PLANNING DIRECTOR'S SPECIAL PERMIT  
1231 "I" STREET, SUITE 200, SACRAMENTO, CA 95814

B. Planning Director's Special Permit to exceed the 25 percent office use allowed in the M-1 zone by allowing 7,818<sup>±</sup> square feet of office in a proposed 15,636<sup>±</sup> square foot warehouse building on 1.04<sup>±</sup> vacant acres in the Light Industrial (M-1) zone.

**LOCATION:** 3670 Business Drive (Building C)

APPLC. NO. P90-427

**EXHIBIT B**

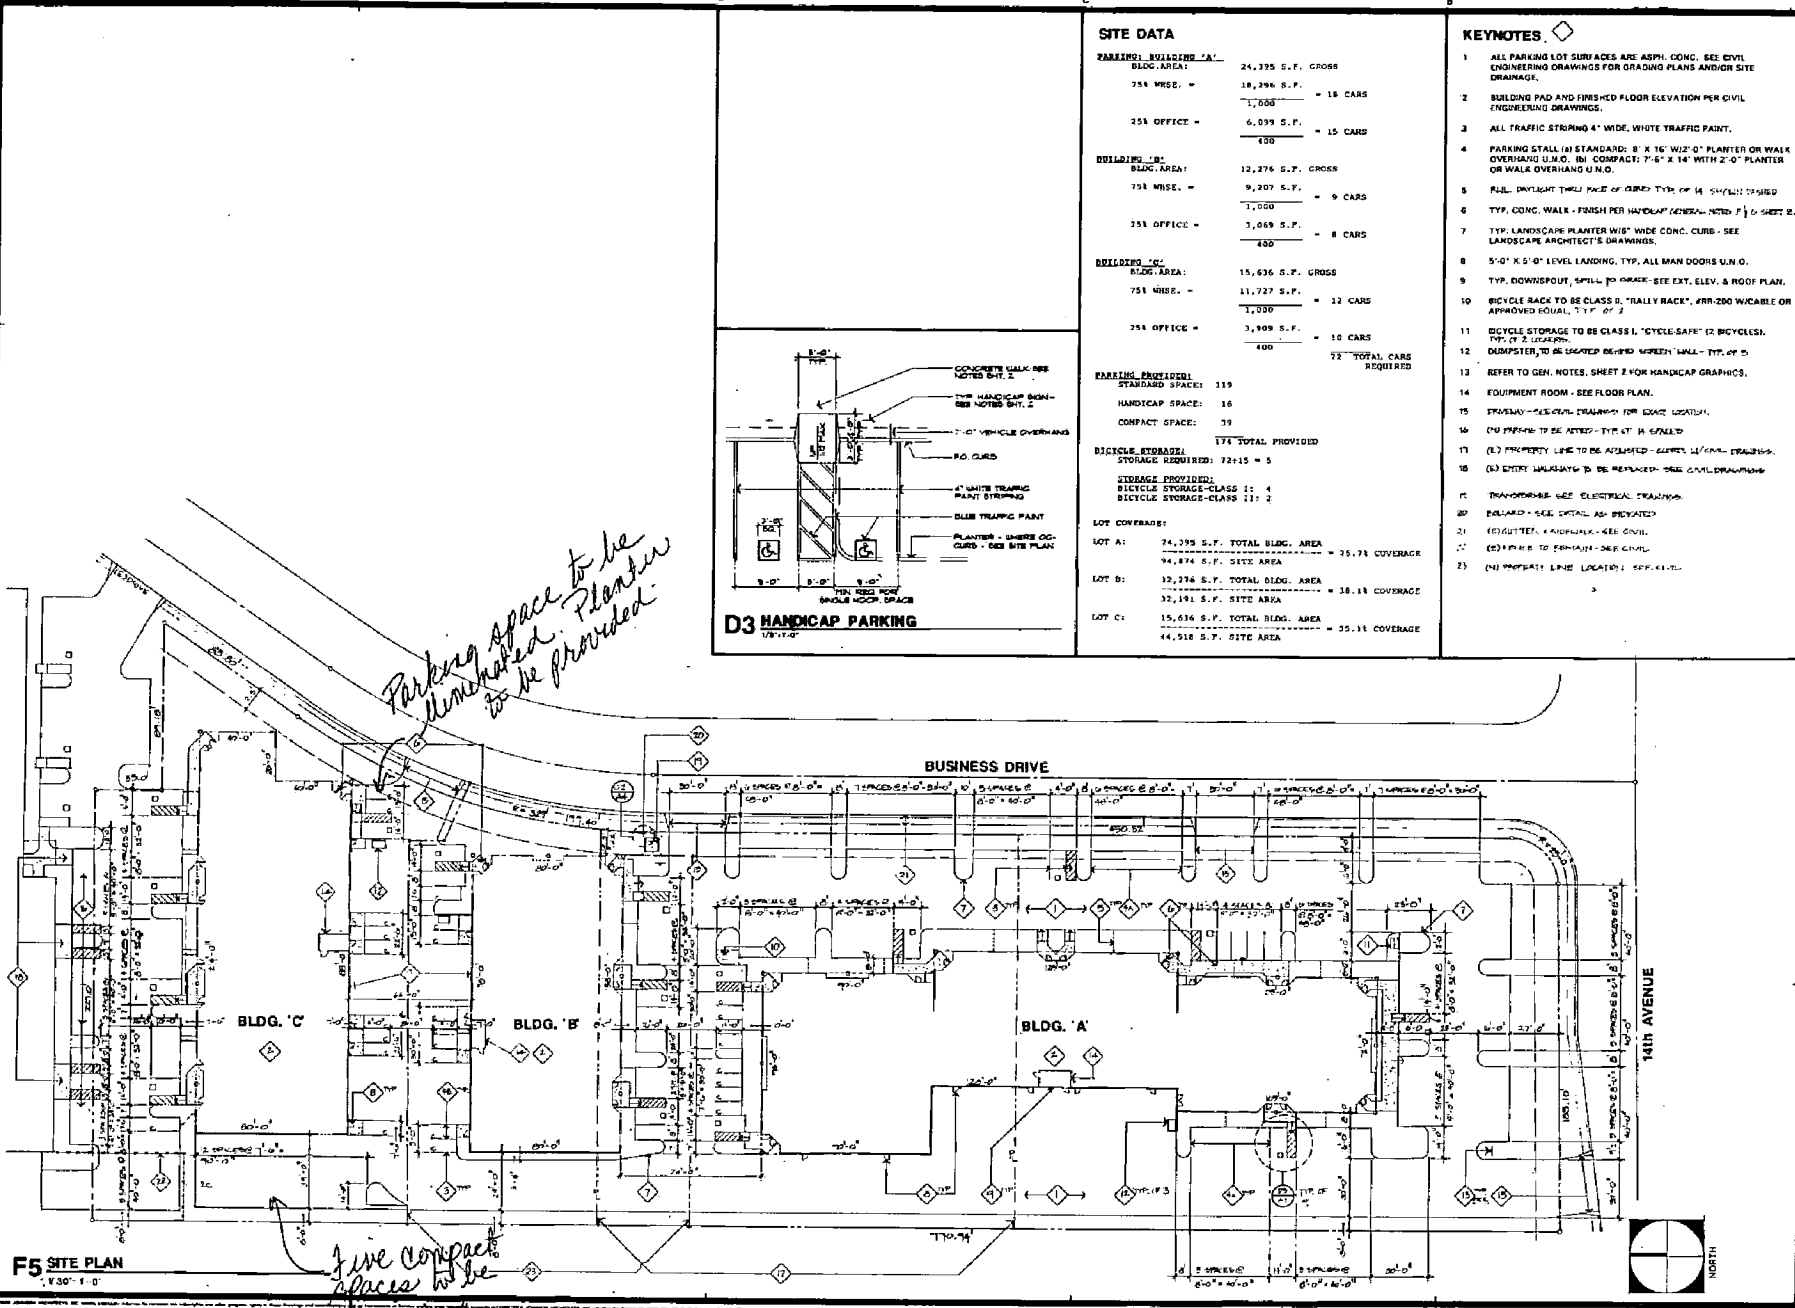
Staff does have some concerns regarding parking on this site. The City Council has adopted an interim parking ordinance which allows up to 40 percent of all required and non-required parking spaces, excluding handicapped spaces, to be sized for compact cars. The compact spaces as proposed on this site exceeds the 40 percent requirement. The site plan indicates 44 parking spaces with 21 spaces designated as compact. The applicant will need to eliminate six compact spaces in order to conform to the Interim Parking Ordinance. The use as proposed requires 27 parking spaces, with the elimination of six compact spaces the site will still provide more than the required parking.

The compact space located at the southeast corner of the building encroaches into the driveway entrance (Exhibit B). Staff recommends this space be eliminated and a planter be located in this area. Staff further recommends five spaces be eliminated at the rear (west) of the site and be replaced with additional planter areas at the sides and middle of this parking section (Exhibit B). By incorporating additional planter space in this area it will eliminate the parking area and prevent cars from parking in the unmarked spaces. It is staff's judgement that converting the compact spaces to standard parking could not be provided unless the building size is reduced or redesigned.

The plans do not indicate any bicycle parking. The Zoning Ordinance requires one bicycle parking space for every 15 off street parking space required for office space and one bicycle parking space for every 25 off street parking space required for warehouse. A minimum of one bicycle space is required for this development. This one space must meet Class I requirements.

The submitted plans do not indicate the location of a trash enclosure. If a dumpster is used a trash enclosure is required. The trash enclosure must meet the requirements of the Zoning Ordinance. Staff recommends that the trash enclosure not be located within the 25 feet building setback along the west property line.

Traffic Engineering - Redesign parking in front of Building C and adjacent to driveway on Business Dr. to the satisfaction of the City Traffic Engineer

2. The proposed parking plan shall conform to the Interim Parking Ordinance which allows 40 percent of required and non-required parking spaces to be compact spaces.

3. Five compact spaces shall be eliminated at the rear (west) of the site and additional planter area shall be provided. The redesign of the parking area shall be subject to review and approval of the Planning Director.

4. The compact space located at the southeast corner of the building which encroaches into the driveway entrance shall be eliminated and a planter be located in its place. The redesign of the driveway shall be to the satisfaction of the City Traffic Engineer.

5. If a dumpster is used, a trash enclosure which meets the requirements of the Zoning Ordinance must be provided. This trash enclosure shall not be located within the 25 foot non-buildable setback easement along the west property line.

6. The minimum bicycle parking shall be provided in accordance with the Zoning Ordinance. Additional bicycle parking may be required as a TMP measure.
7. No outside loud speakers shall be located at the rear of the structure.

# EXHIBIT A SITE PLAN

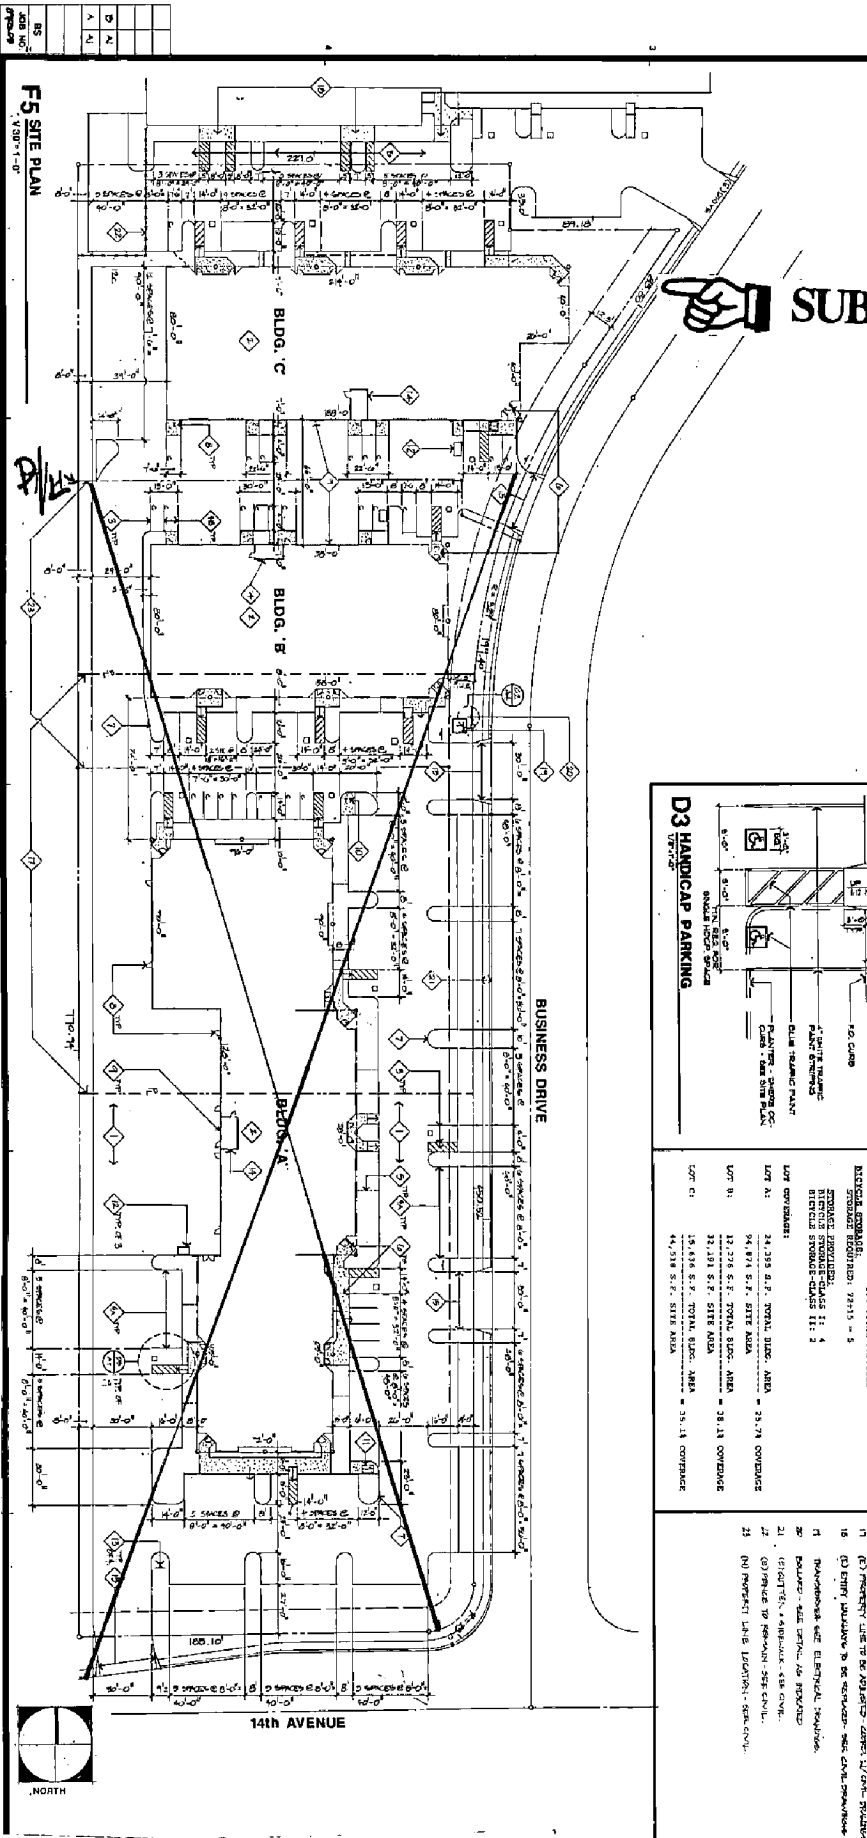
**Background:** On January 8, 1987 the Planning Commission recommended approval of a tentative map to subdivide 25<sup>±</sup> vacant acres into 15 lots for future industrial development (P87-010). On February 10, 1987 the City Council approved the tentative map with several conditions to protect the residential uses to the west. On August 23, 1990, the Planning Commission approved a lot line adjustment (P90-300) to relocate the common property lines between three vacant lots totaling 4.7<sup>±</sup> acres in the M-1 zone. The Assessor's Parcel maps do not indicate that a certificate of compliance has been recorded. The applicant has applied for Planning Director's Special Permits to exceed the 25% office use on these three lots (P90-427, P90-428 and P90-429). The subject site is the northern most lot of these three lots (Exhibit A).
